***Interactive comment on “Uncertainties in using
remote sensing
for water use determination: a case study in
a heterogeneous study area in South Africa” by
L. A. Gibson et al.***

L. A. Gibson et al.

Received and published: 24 November 2010

Fig. 1. Revised Figure 2

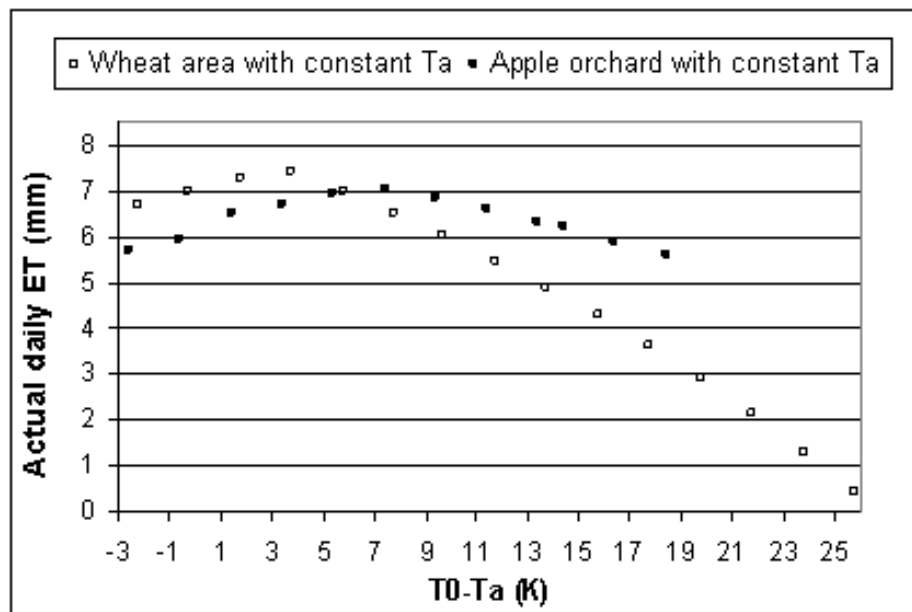
(2) As it can be seen in Eq.23 in Su (2002), sensible heat flux (H) is directly related with temperature gradient between land surface and near surface air ($T_0 - T_a$), while it is inversely related with aerodynamic resistance term in the denominator. As the author mentions, Su (2002) indicates the sensitivity of H as $\Delta H = 10 \Delta(T_0 - T_a)$, which is similar by the finding of the author for wheat land cover. In theory (according to Eq 23 in Su, 2002), higher the temperature gradient, higher H gets. And, since SEBS calculates LE as the residual of the surface energy balance, higher the H gets lower the LE becomes for the same available energy. This is also confirmed by the decreasing trend of daily ET with increasing ($T_0 - T_a$) in Fig2 (p.6605) for wheat land cover. However, there is a completely different correlation between daily ET and ($T_0 - T_a$) for the case of apple

orchard as shown in Fig. 2, and stated in p.6590 between L5-10. It would be good to discuss in more detail why daily ET start to decrease with decreasing (T_0-T_a), when (T_0-T_a) gets smaller than 8, assuming other parameters are the same? For example, in p.6588, L16-19, it is mentioned the role of T_0 in the calculation of aerodynamic resistance? Could it be explained more explicitly how?

On p.6588, L16-19 has been poorly formulated. We would like to change this to: “its main contribution (together with the aerodynamic resistance) is in the calculation of the sensible heat flux.”

SEBS limits evapotranspiration by setting a wet and a dry limit. In the apple orchard at $T_0-T_a < 7.4$, the sensible heat flux is at the wet limit. At the wet limit, the equation used to calculate the sensible heat flux is given in Su (2002) Eqn 16 which differs from the sensible heat flux equations which are used when the wet limit has not been reached (Su, 2002; Eqns 4-6). In Equation 16, with decreasing T_0-T_a , the denominator is decreased by a decrease in the Δ (the rate of change of saturation vapour pressure with temperature) and therefore the sensible heat flux at the wet limit increases, resulting in a decrease in the latent heat flux, a decrease in the evaporative fraction and a decrease in the daily evapotranspiration. It is believed that this is the reason for the decrease in daily actual evapotranspiration with T_0-T_a once the wet limit has been reached.

Where the wet limit has not been reached, Eqn 5 (Su, 2002) is used in the determination of the sensible heat flux. In Eqn 5, with decreasing T_0-T_a , there will be decreasing sensible heat flux estimation, resulting in increasing latent heat flux and therefore increasing daily actual evapotranspiration. This explains why the daily actual evapotranspiration increases with decreasing T_0-T_a until the wet limit is reached. At the wet limit a different equation is used (Eqn 16) and the daily evapotranspiration decreases with decreasing T_0-T_a due to decreasing saturation vapour pressure.

In SEBS, the wet limit equations are used when the sensible heat flux calculated using

Eqns 4-6 in Su (2002) is less than or equal to the sensible heat flux at the wet limit calculated using Eqn 16. In the case of the wheat growing area, the wet limit was not reached when using similar T_0-T_a values as was used for the apple orchard scenario. This is possibly due to the calculated lower roughness lengths of the wheat fields (in combination with different atmospheric conditions) when compared with the apple orchard, resulting in a higher sensible heat flux for the same T_0-T_a as observed in the apple orchard (Eqn 5). For this reason in the selected T_0-T_a range used in this paper, the sensible heat flux was not calculated to be low enough using Eqns 4-6 to force it to the wet limit and this is why the decrease in evapotranspiration with decrease in T_0-T_a is not observed as it was in the apple orchard. In the revised paper we will extend the range shown for the wheat growing area on Figure 2 to show the wet limit drop off in evapotranspiration which occurs at $T_0-T_a \sim 3$ in this particular instance.

See Revised Figure 2
